UNITED STATES PATENT AND TRADEMARK OFFICE

APPLICATION NO.	FILING DATE	FIRST NAMED INVENTOR	ATTORNEY DOCKET NO.	CONFIRMATION NO.
09/975,417	10/10/2001	Paul Swift	34580.001CC	9594

Office Action Summary

SWIFT

A

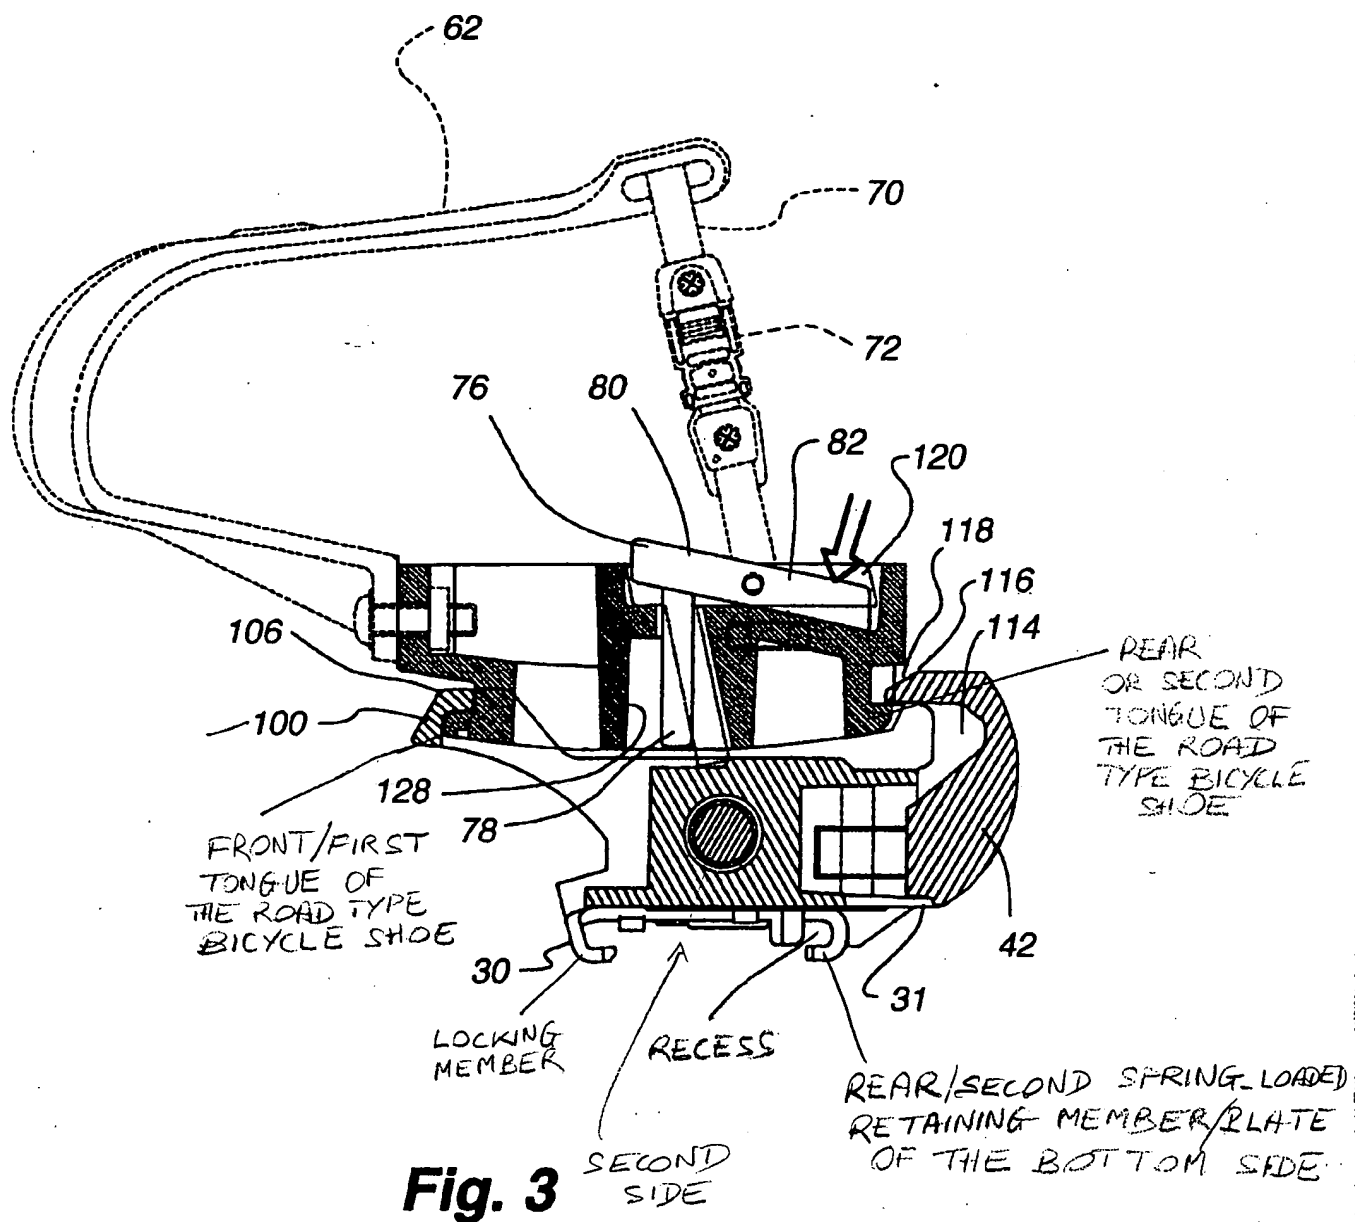
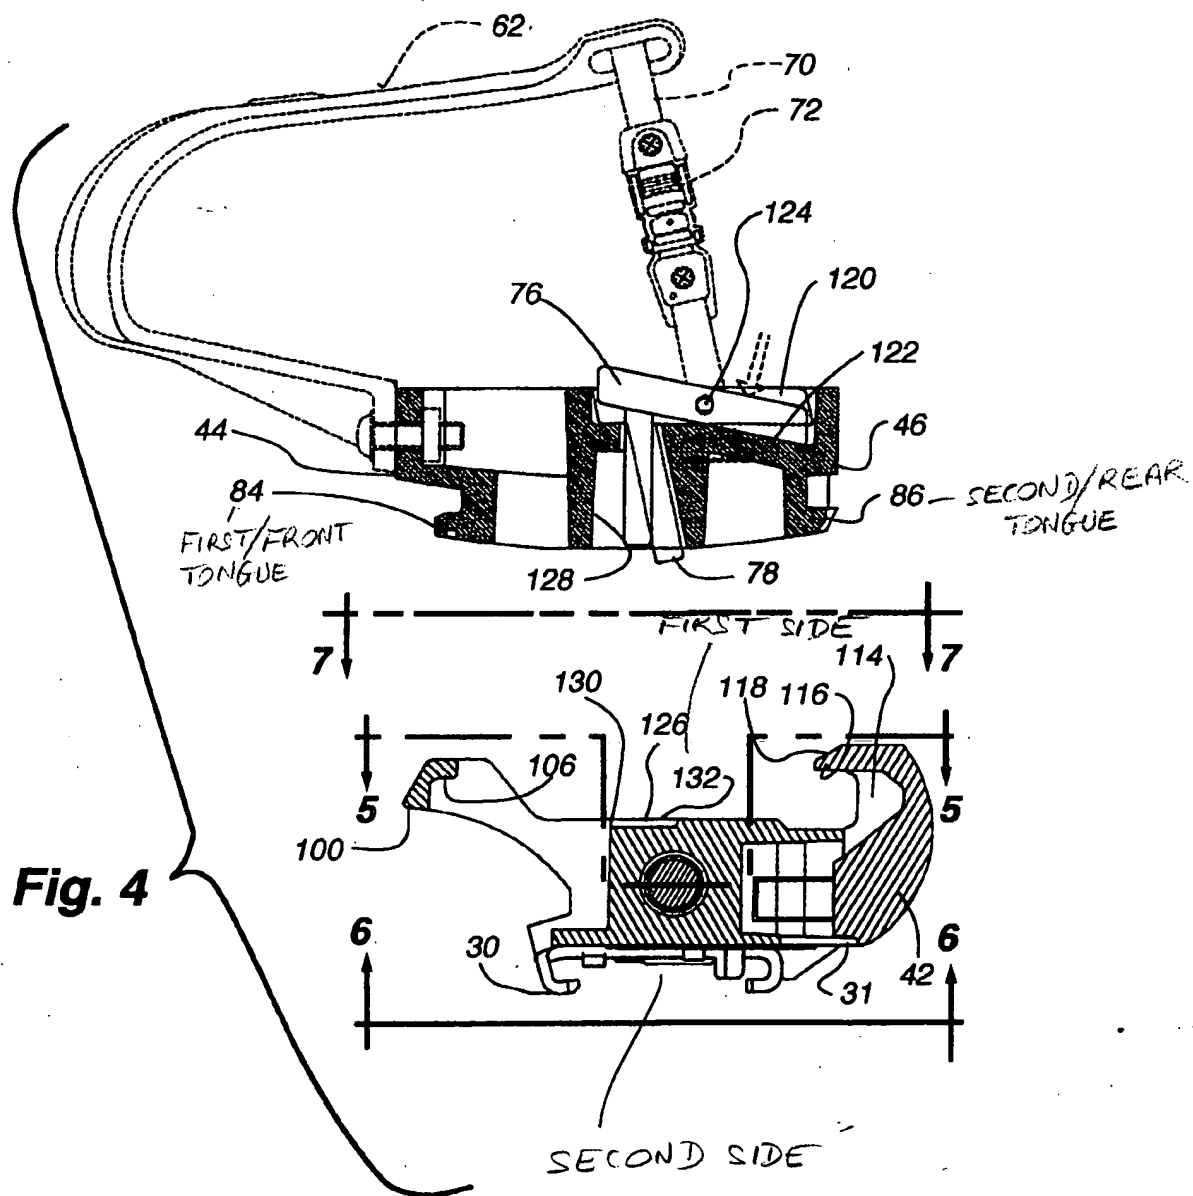
b. said first side 28 conforming to a bottom of a road type bicycle shoe cleat 22 and having means 100, 106 for receiving a first tongue 84 (Attachment A) of the road type bicycle shoe cleat 22, said first side 28 also having a first spring-loaded retaining plate 42 pivotable on the main body 24 for receiving a second tongue 86 of the road type bicycle shoe cleat 22 and when a force is applied to the first spring-loaded retaining plate 42, the first spring-loaded retaining plate 42 moves away from said main body 24 such that the second tongue 86 is retained within the

C

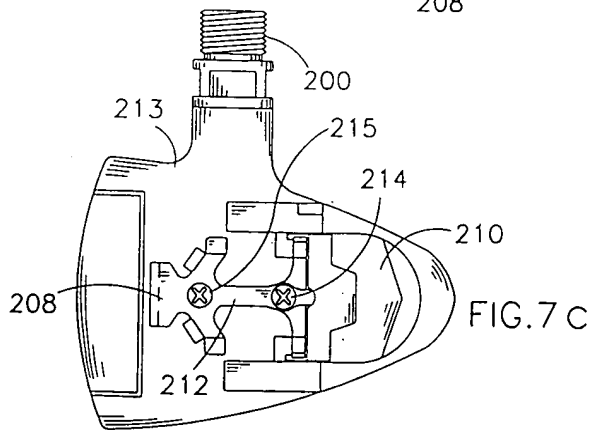
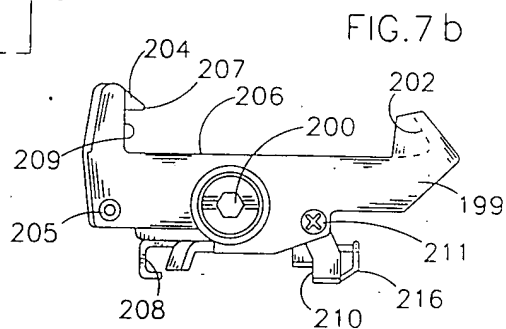
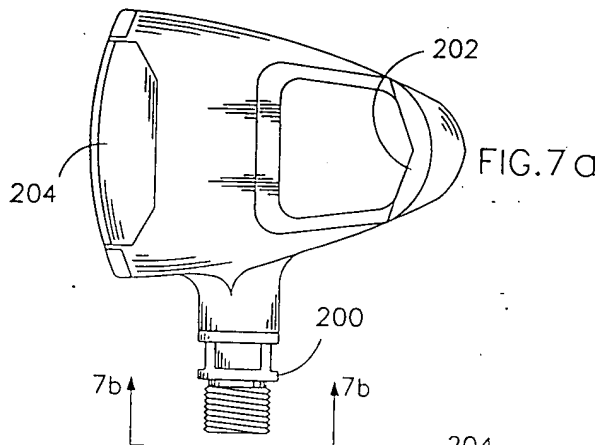
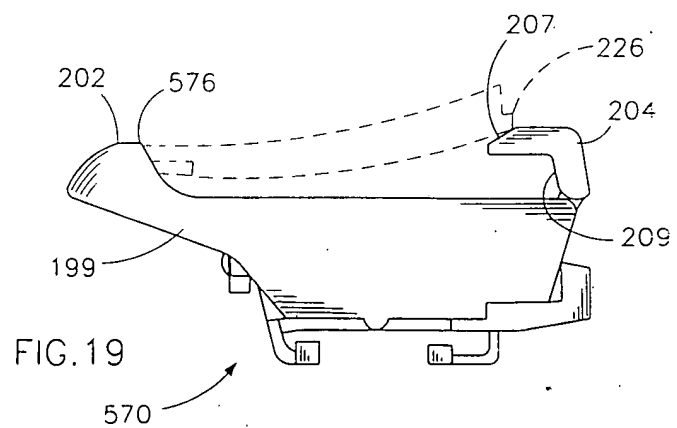
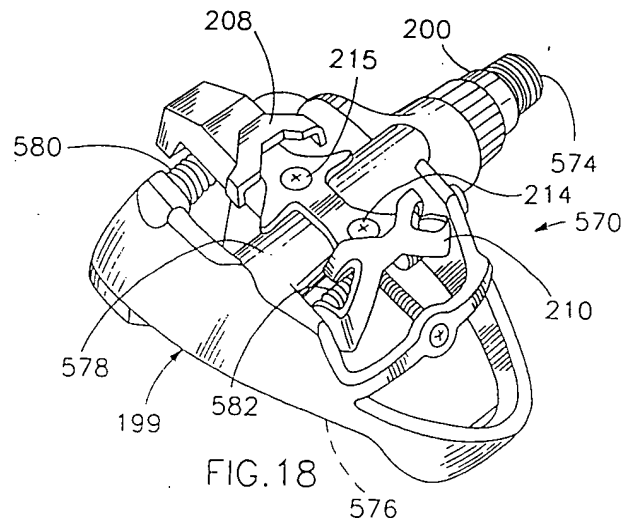
Second, applicant compares Figs. 18 and Figs. 7a-7c of this application and asserts that *"everything that the Applicant is disclosing and claiming in the present '417 Application was in fact disclosed in the original application filed on September 3, 1997."* (Page 11 of Paper 5).

Contrary to applicant's remarks, the comparison of Figs. 18 and Figs. 7a-7c of this application shows that *everything that the Applicant is disclosing and claiming in the present '417 Application was in fact not disclosed in the original application filed on September 3, 1997*. To illustrate this point, the examiner respectfully refers to Attachment C wherein Figs. 7a-7c are shown on the left side and Figs. 18 and 19 are shown on the right side. One may reasonably recognize that the spring plate 204 of the first pedal in Fig. 7b is patentably distinct from the spring plate 204 of the second pedal in Fig. 19 due to the pivoted recess 209 and the springs 580 and 582.

D

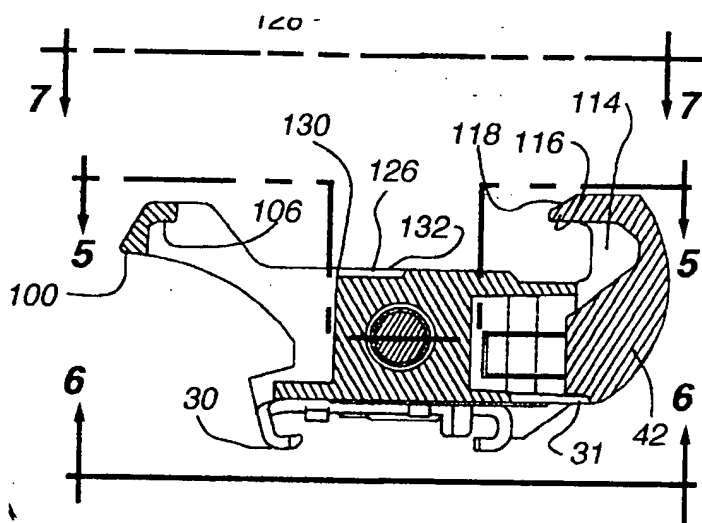
In the case at hand, applicant's recitation of the intended use of applicant's claimed invention does not result in a structural difference between the claimed invention and the prior art Gapinski. To illustrate this point, the examiner prepares Attachment D wherein applicant's claimed pedal in Fig.

19 is shown side by side with Gapinski's pedal. One may reasonably infer from Attachment D that Gapinski's pedal is substantially identical to applicant's pedal.
